Public Consultation
Submission Report –
Second & Third Non-
Statutory Public
Consultation

Kimmage to City Centre Core Bus Corridor

Preferred Route Option

Second and Third Public Consultation Submissions Summary Report

Section 2 – Sundrive Cross to Harold’s Cross Park

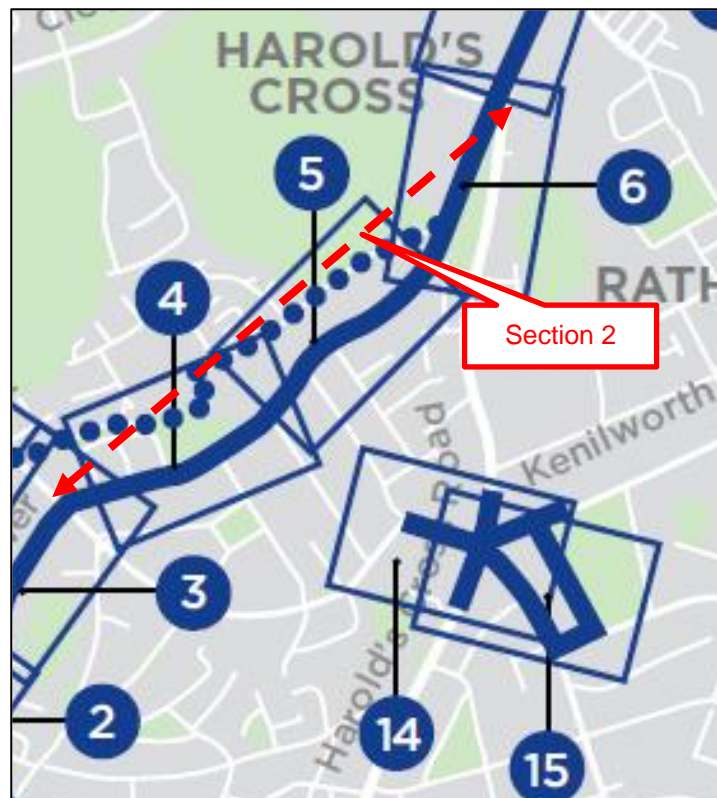
Main comments noted:

Pedestrian and Cycling facilities:

- Cycle lanes on Kimmage Road Lower.
- Proposed new pedestrian and cycle route at the Stone Boat Boardwalk linking Sundrive Road to Mount Argus.
- Traffic speed on Kimmage Road Lower and safety for pedestrians and cyclists.

Section 3 – Harold’s Cross Park to Grand Canal

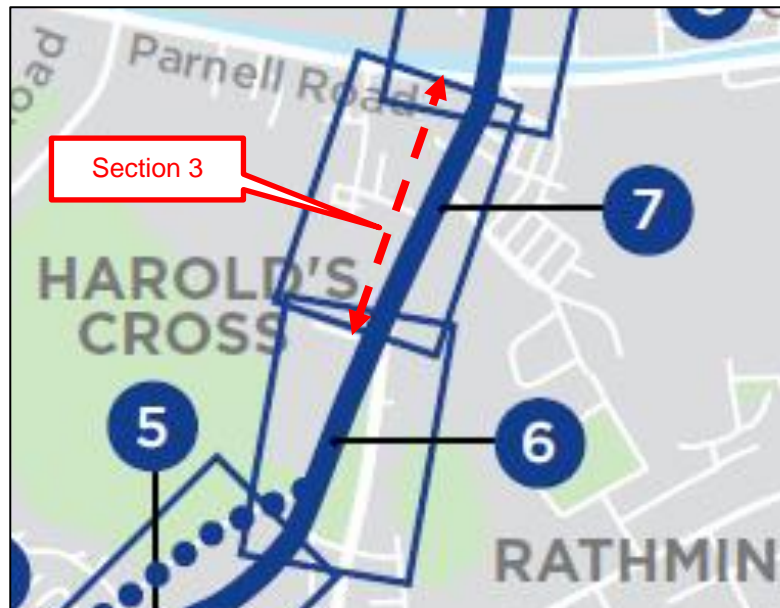
Main comments noted:

Pedestrian and Cycling facilities:

- Cycle tracks on Harold’s Cross Road rather than cycle route via Greenmount Lane.

Section 4 – Grand Canal to Patrick Street

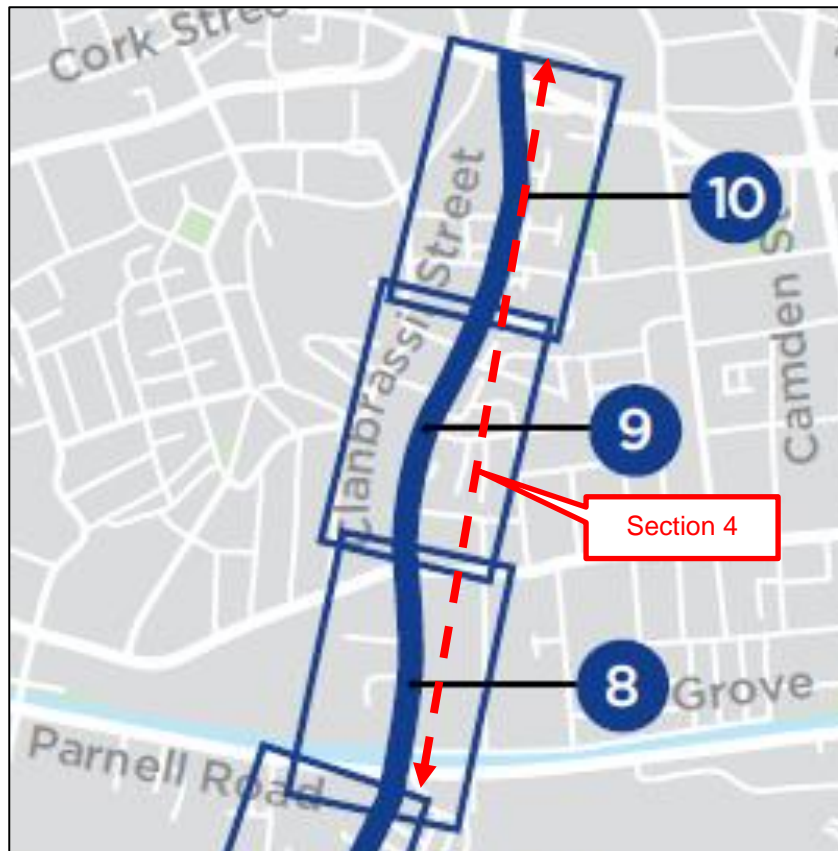
Main comments noted:
